# Review of Long-Term Maintenance Plans for the South Jetty, Grays Harbor, Washington

by *Special Subcommittee of the Committee on Tidal Hydraulics and  
Coastal Engineering Research Board*

Final report

Prepared for U.S. Army Engineer District, Seattle  
Seattle, WA 98124-2255

Figure 15. Beach revetment alternative

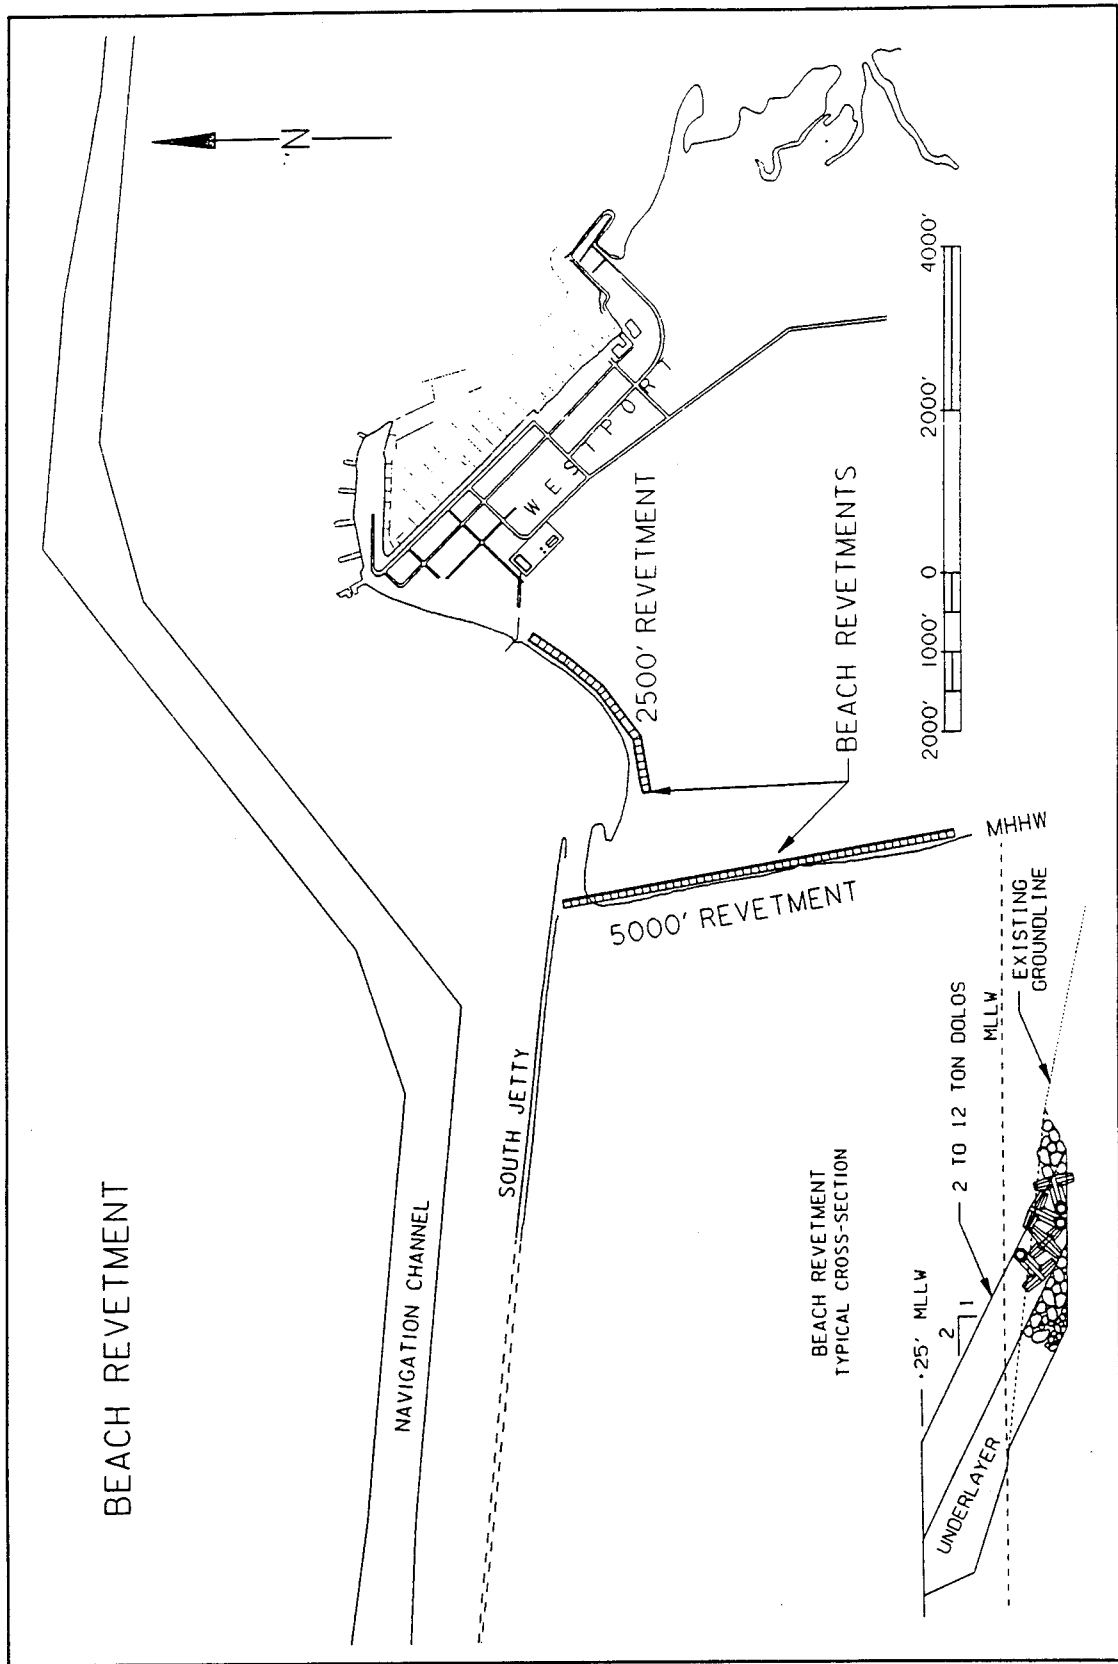
46. This alternative is shown in Figure 15. It includes revetment along South Beach and extension of the revetment in Half Moon Bay. In addition to a very high initial cost, erosion of sand at the base of the revetment down South Beach would cause continuing requirements for expensive maintenance.

Figure 16. South jetty extension and revetment alternative

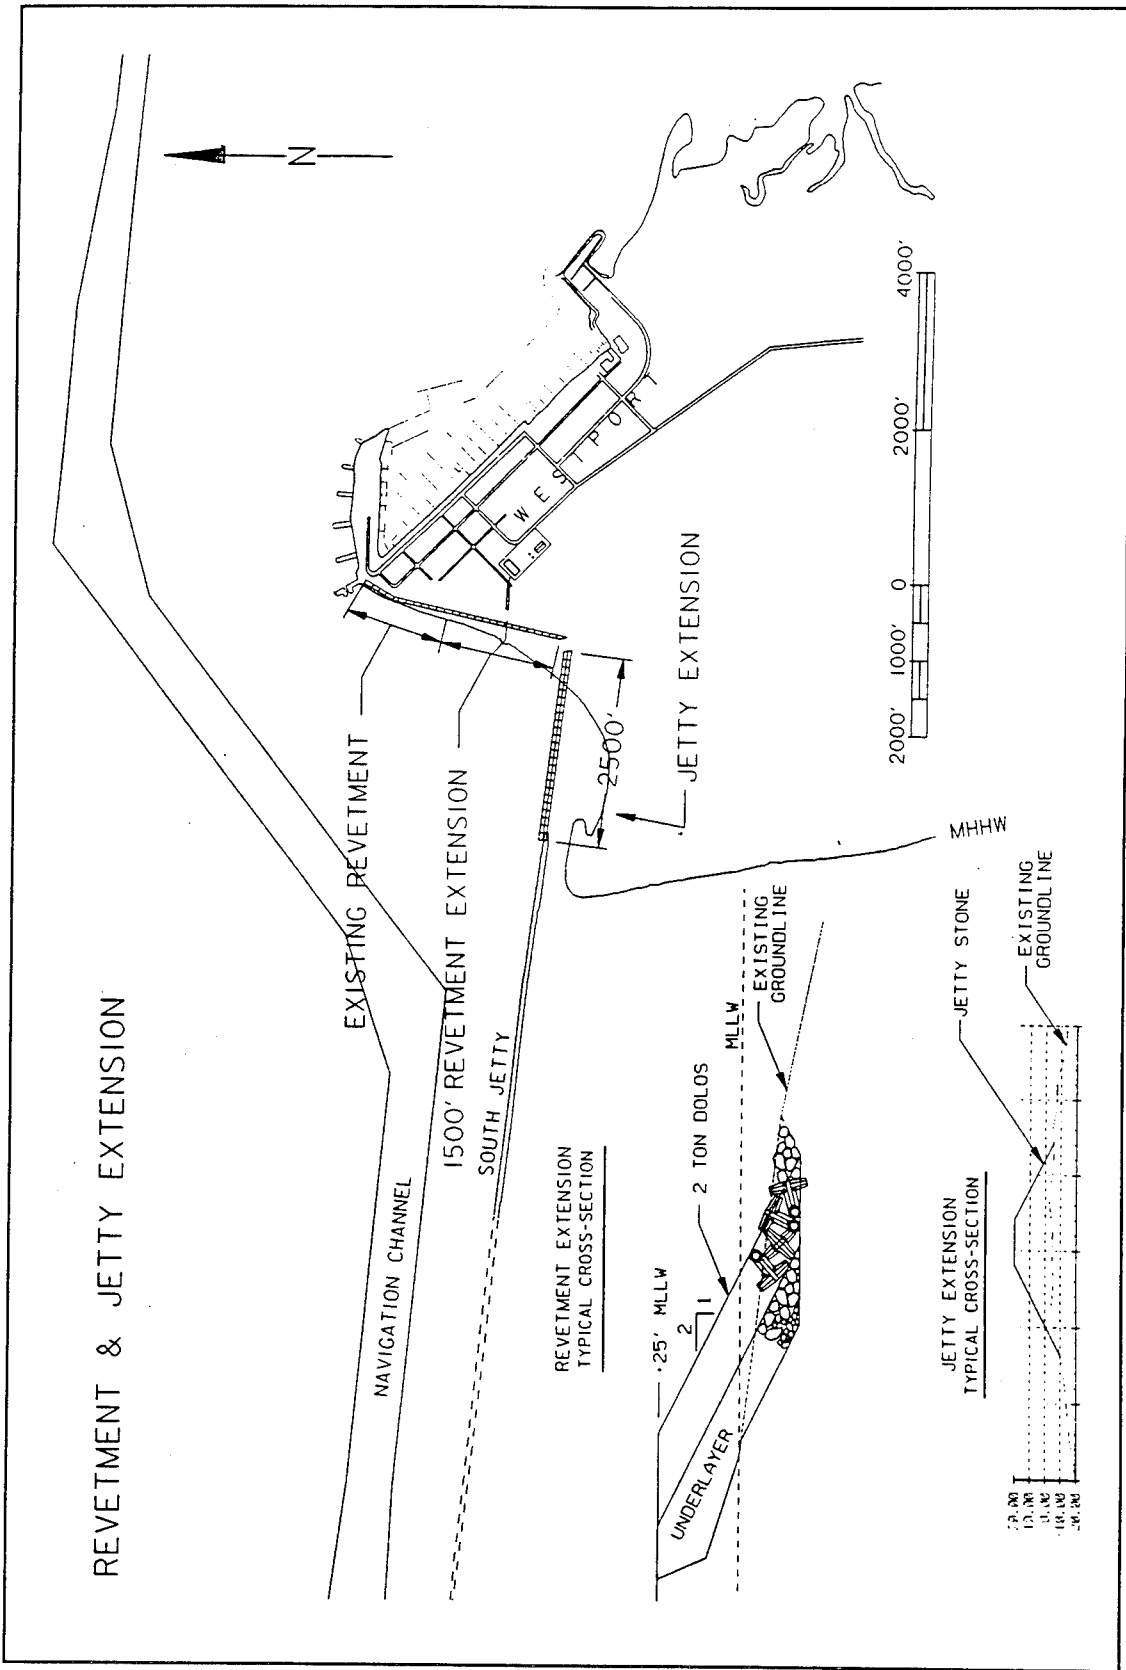
47. This alternative is shown in Figure 16. It includes a 2500-ft eastward extension of the jetty to the junction of a 1500-ft southward extension of the Westport revetment. Protection against erosion in the Half Moon Bay area and of Point Chehalis against waves and currents in the entrance would be provided. This plan would also provide assurance that the entrance channel would not be captured by South Beach erosion in the breach area. Curvature of the jetty near its junction with the revetment extension to provide a smooth alignment along the channel bend would reduce construction and maintenance costs. No means of reducing erosion of South Beach is shown.

Figure 17. Spur groin alternative

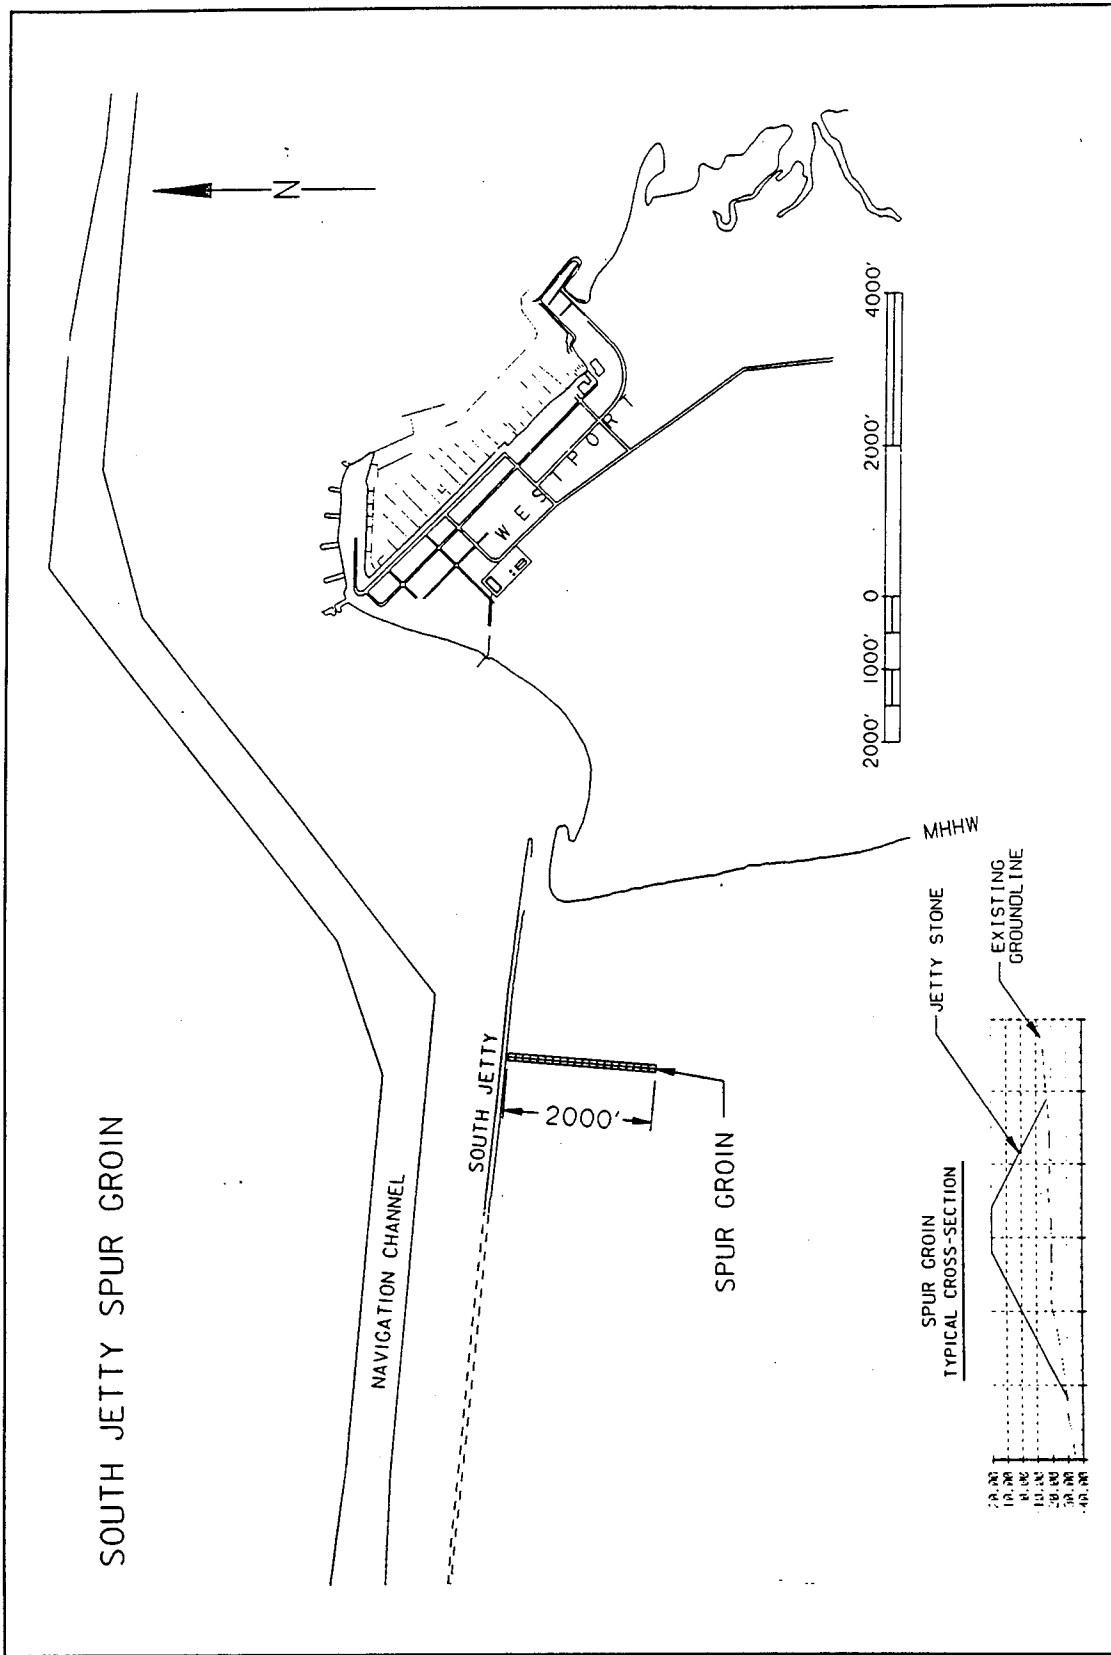
48. This alternative is presented in Figure 17. It includes a 2000 ft groin perpendicular to and on the south side of the South Jetty located about 2000 ft from its east end. No direct closure of the breach is indicated; however, the intent of the groin is to interrupt the seaward current along the jetty and to facilitate accumulation of sand in the breach area and out along the south jetty. This alternative could provide long term protection of the jetty but would require expensive maintenance. It would not diminish erosion in Half Moon Bay. Its efficacy depends on a supply of sand from the south, possibly augmented by placement of dredged material. Design of such a groin should include computations of northward littoral transport and possibly a physical model study to determine optimum location and length of the groin.

Figure 18. South jetty reinforcement alternative

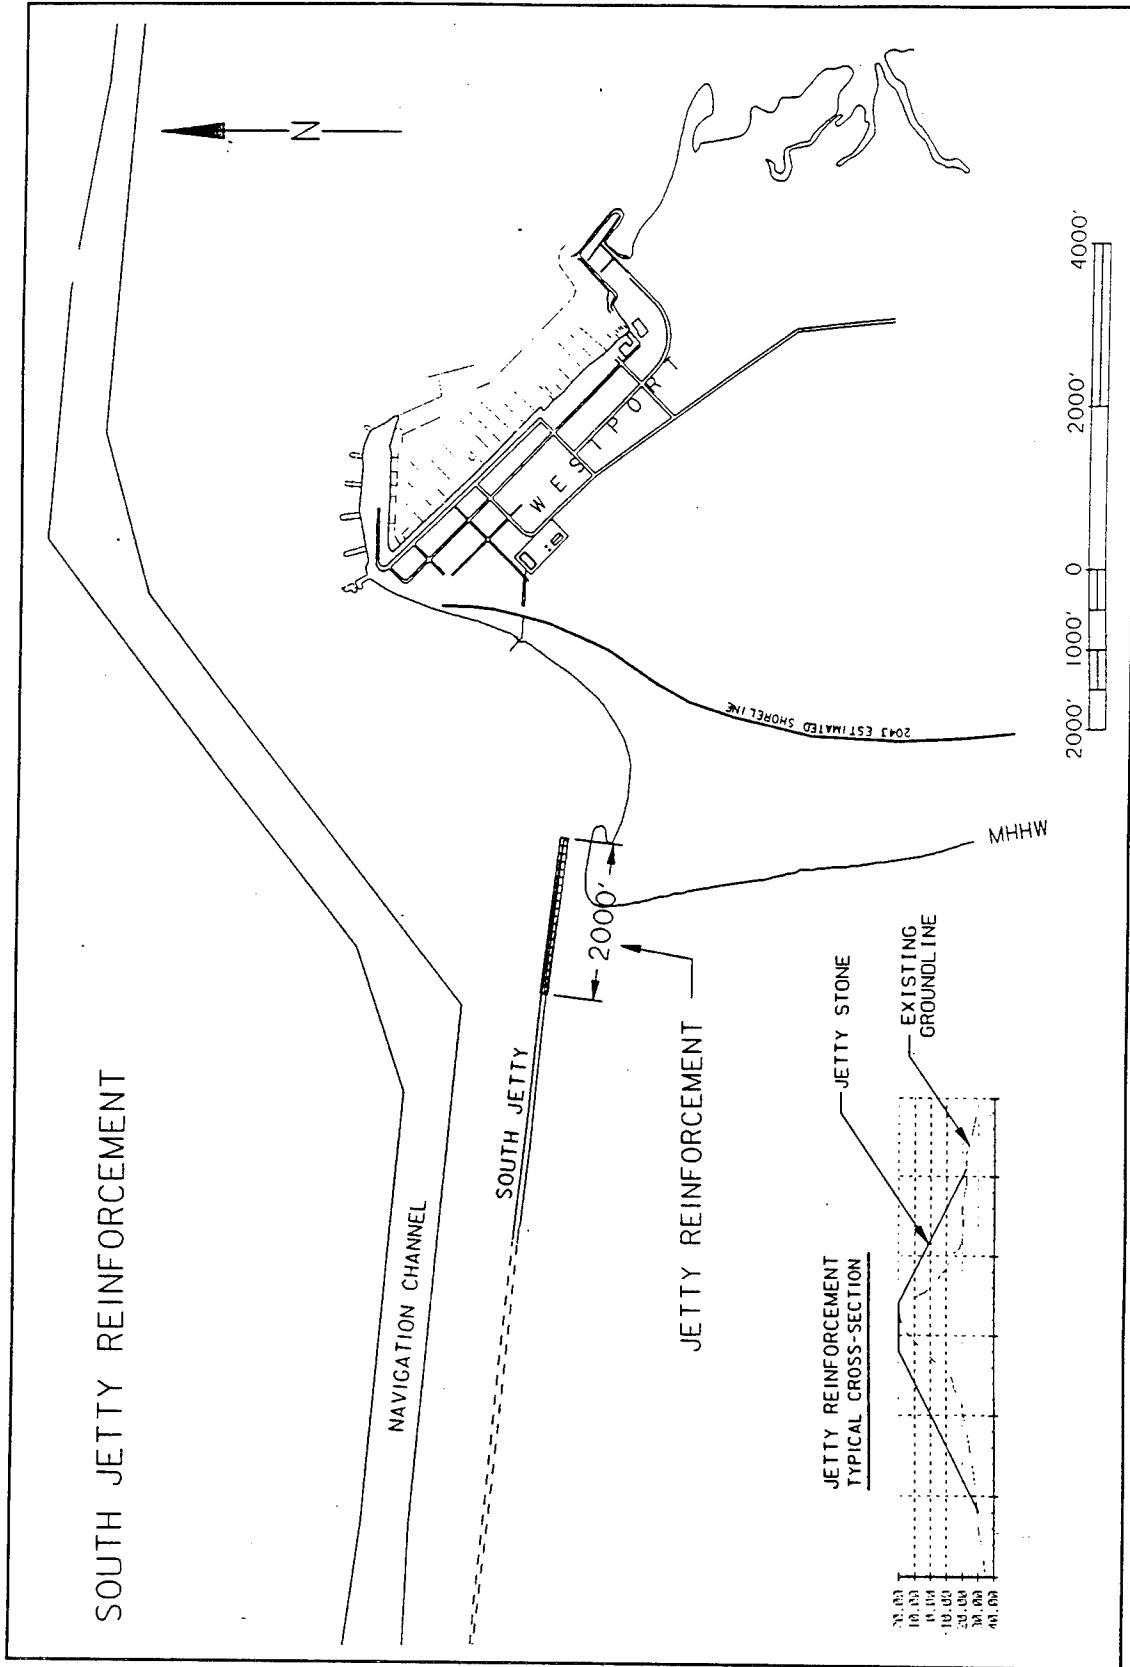
49. This alternative is presented in Figure 18. It includes reinforcement of 2000 ft of the east end of the south jetty. It would maintain stability of the structure in the presence of continuing erosion of South Beach and Half Moon Bay. Continuous monitoring of the beach would be required, and risk of capture of the navigation channel by erosion of the breach would persist.

Figure 19. Nearshore berm alternative

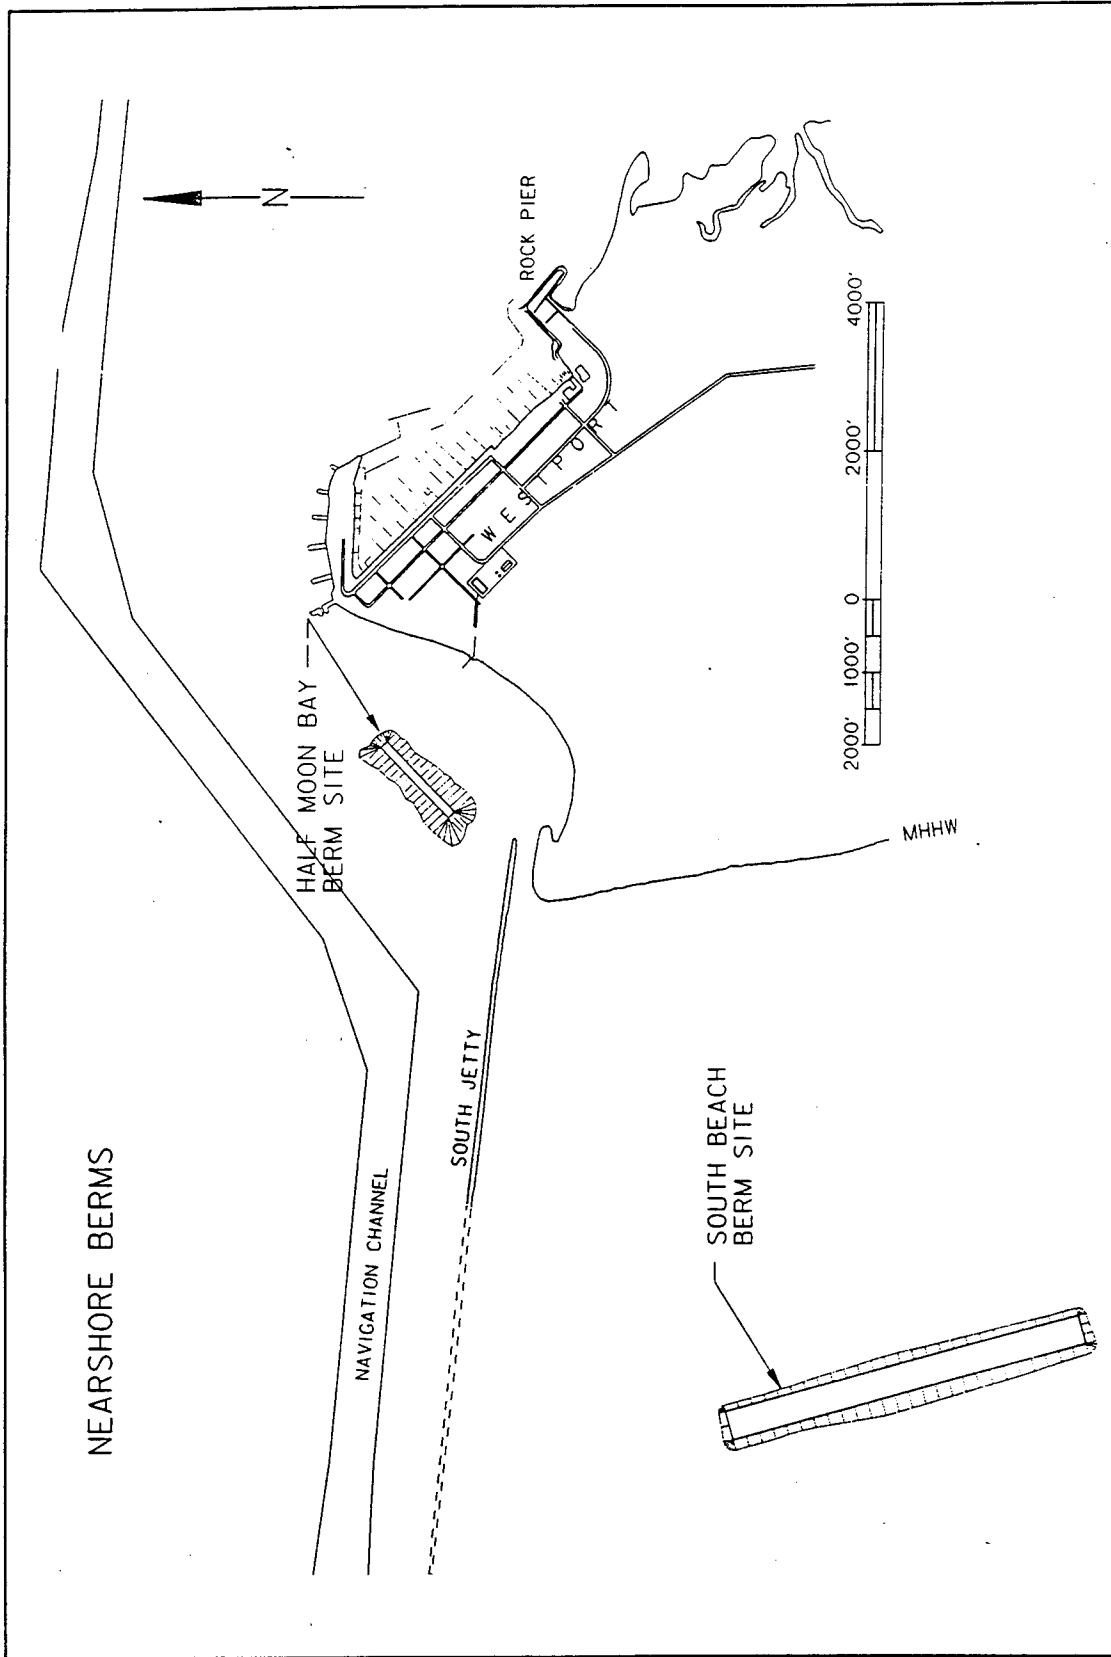
50. Annually resupplied nearshore berms shown in Figure 19 would be placed in Half Moon Bay and near the north end of South Beach. The purposes of these berms would be to reduce wave action and supply sand to the beaches. Up to 500,000 cubic yards a year of sandy dredged material could be placed between the -20 and -40 ft contours near South Beach. The berm would cover an area 5000 ft long by 500 ft wide. An initial berm 2000 ft long containing 385,000 cy of sand was placed at the 40-ft contour during September and August, 1993, and an additional deposit is planned at the 30-ft contour in September, 1994. An initial 185,000 cy berm was placed in Half Moon Bay in 1992 and an additional 200,000 cy was added in May, 1994. Placement of these berms costs little above the cost of the previous disposal operations, and the practice should be continued to retard shoreline erosion.
